Addendum 05

PROJECT: Village of Minster Library Elevator Renovation
196 East 4th Street
Minster, OH 45865

PROJECT #: 25097.00

This addendum form is a part of the Contract Documents and modifies the Construction Documents dated September 17, 2026, with amendments and additions noted below.

AD1.0a

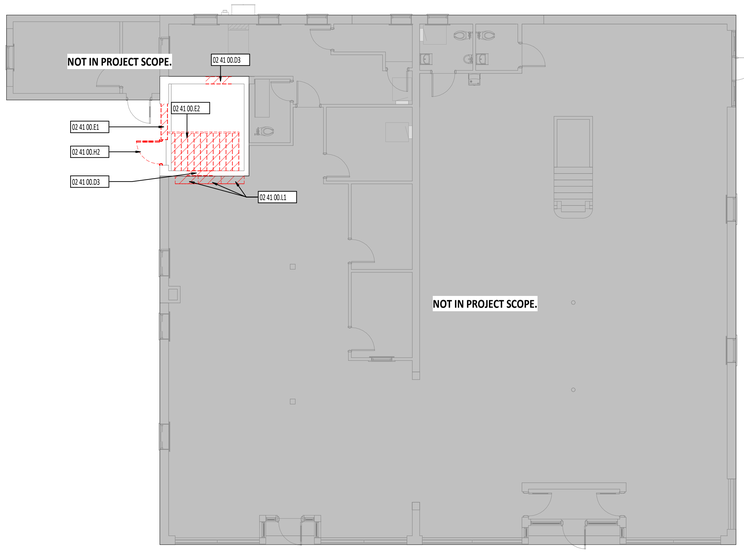
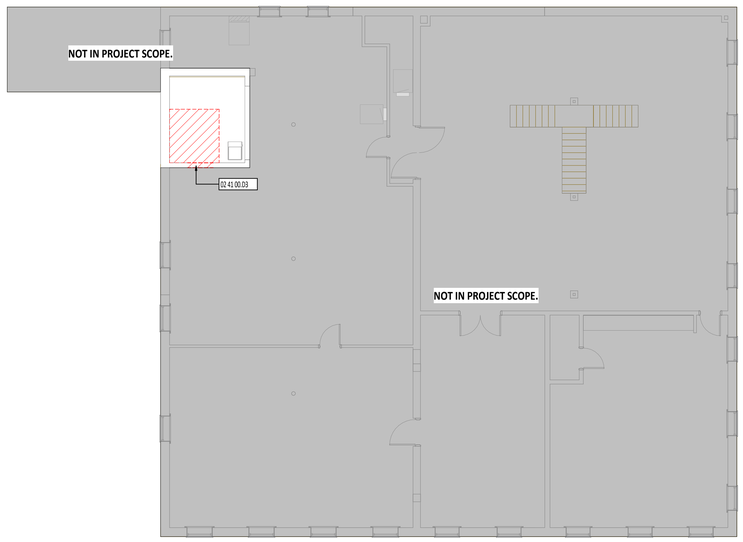
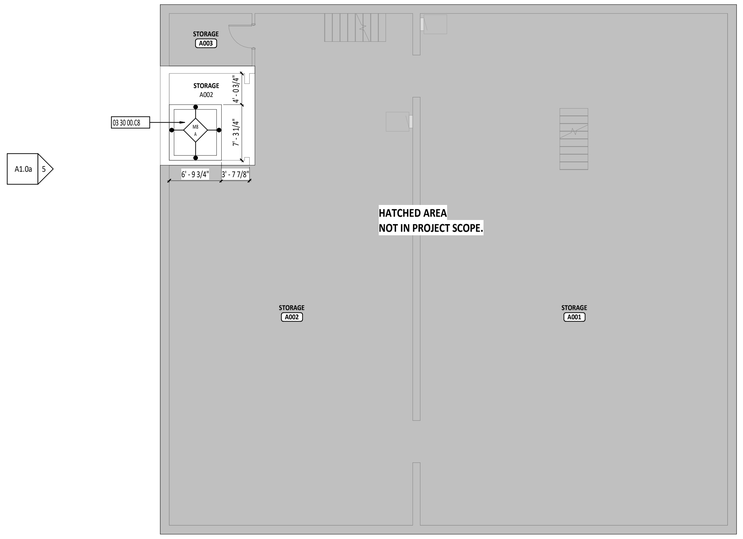
1. Drawing Sheets AD1.0a, A1.0a, A3.1, A6.1 - Added 1 hour fire rating designation to elevator shaft walls and existing machine room walls. Added 1 hour rated construction to elevator machine room floor and ceiling
2. Drawing Sheet M2.1 – Second Floor Mechanical Plan:
   a. Add exhaust fan.
3. Drawing Sheet E2.1 - Electrical Plans:
   a. Relocated switch in room A100 to avoid interference with the new door location.
   b. Relocated the disconnect in room A100 to avoid interference with the new door location.
